KPB 2025-140

**ITEM #2 - PRELIMINARY PLAT
BARNETT LOT 1-A 2025 RESUB**

KPB File No.	2025-140
Plat Committee Meeting:	October 13, 2025
Applicant / Owner:	Range Group LLC of Sheridan, Wyoming
Surveyor:	Christopher Mullikin, Mullikin Surveys LLC
General Location:	East Hill Road and Barnett Place, City of Homer

TO: Homer Advisory Planning Commission
Through: Ryan Foster, City Planner
From: Ed Gross, Associate Planner
DATE: September 3, 2025
SUBJECT: Barnett Lot 1-A 2025 Resubdivision

PRELIMINARY PLAT

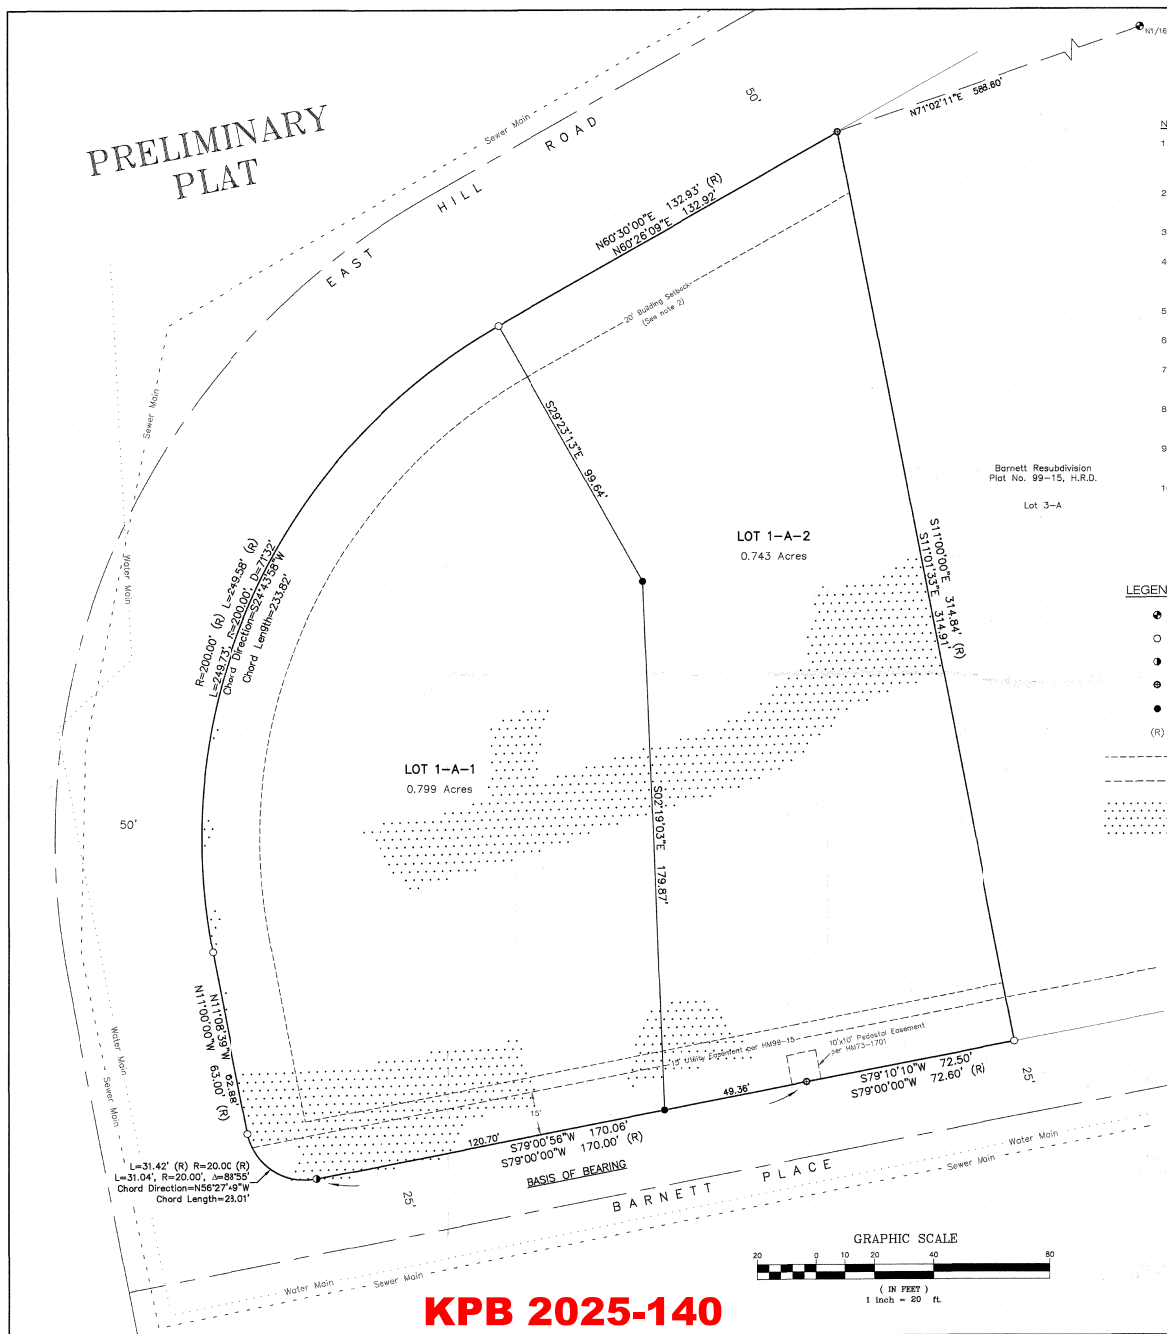
The preliminary plat includes shaded area of grades exceeding 20% as reflected on KPB GIS Imagery Contours Layer. **Staff recommends** Per 20.60.010 contours are not required on a final plat. If the contours remain on the final plat, please label the top and toe of slope.

According to KPB GIS Imagery, no wetlands affect the proposed plat. **Staff recommends** plat note number 9 be removed from the final plat.

Staff recommends plat note 9 be modified to reflect KPB 20.40.070(B). No signature is required by a licensed engineer per KPB 20.40.070(C).

- Modify the KPB File No to 2025-140

- Within the legal description, add City of Homer
- Please modify “Client” to “Owner”
- Within the title block, the owner’s name should reflect CTP and KPB records, “Range Group LLC” and remove Matthew Crawford

- Show the entire 100’ width of East Hill Road
- Show the entire 50’ width of Barnett Place

- Include label for range 14W and R13W at the appropriate line
- Add a label for section 24
- Add a label for the Sterling Highway

- Add labels and lot lines for adjacent lands within 100 feet of subdivision
- Add labels and lot lines for parcels across from East Hill Road

- 15-foot utility easement adjacent to East Hill Road to be granted as requested by COH

- Modify plat note #8 to KPB 20.40.070(B) and provide an agreement from the City stating services are provided prior to final plat approval. Engineer’s signature not required per 20.40.070(C)

- Modify the owner's name under the signature line to "Mathew Crawford, Manager for Range Group LLC"

- Modify the meeting date to October 13, 2025

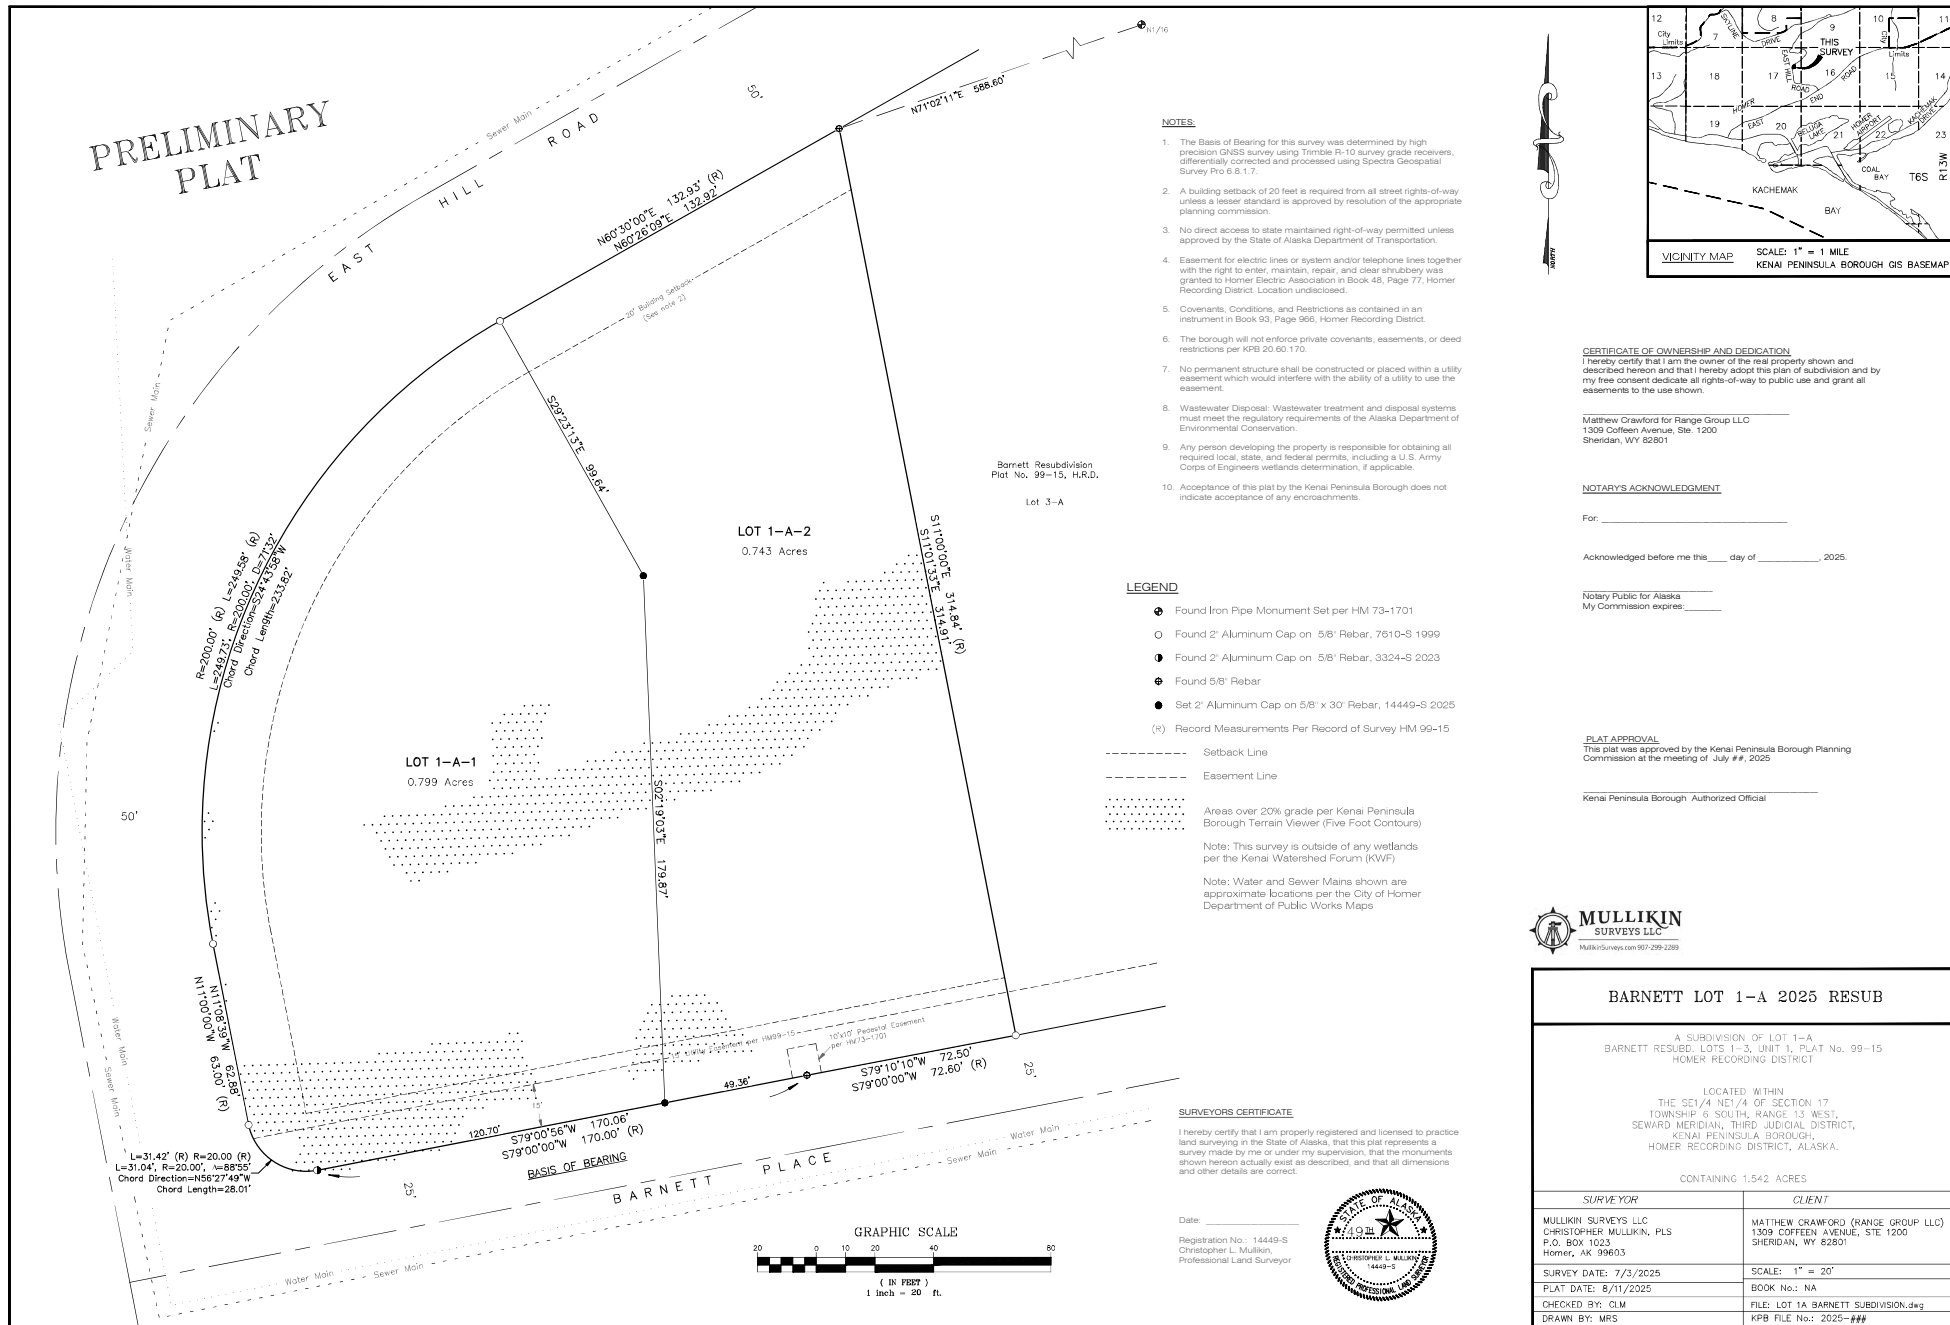
Staff Response: The plat does not meet this requirement. While the plat depicts a 15-foot utility easement along Barnett Place, it does not depict a 15-foot utility easement along East Hill Road. The plat should depict a 15-foot utility easement along East Hill Road

Staff Response: The plat does not meet these requirements. The proposed plat only identifies the street width to the centerline. Recommend showing the entire width of streets.

Staff Response: The plat does not meet these requirements. The proposed plat only identifies the street width to the centerline. Recommend showing the entire width of streets.

Staff Response: The plat does not meet these requirements. Adjacent parcels should be identified, including Lot 7 and Lot 8 across Barnett Place.

1. Water and sewer services will need to be provided to the newly subdivided lot prior to recording the final plat.
2. The existing plat indicates a total area of 1.543 acres, yet the preliminary plat indicates 1.542 acres. Please clarify the total acreage of the lot.
3. The note, “15’ Utility Easement per HM99-15” and the associated dimensioning arrow with 15’, depicted along Barnett Place conflicts graphically with the hatch indicating 20% or greater slopes. This note and dimensioning, should be moved so that they do not conflict the hatching.
4. Recommend showing the entire width of streets (not just to centerline).
5. Adjacent parcels should be identified, including Lot 7 and Lot 8 across Barnett Place.
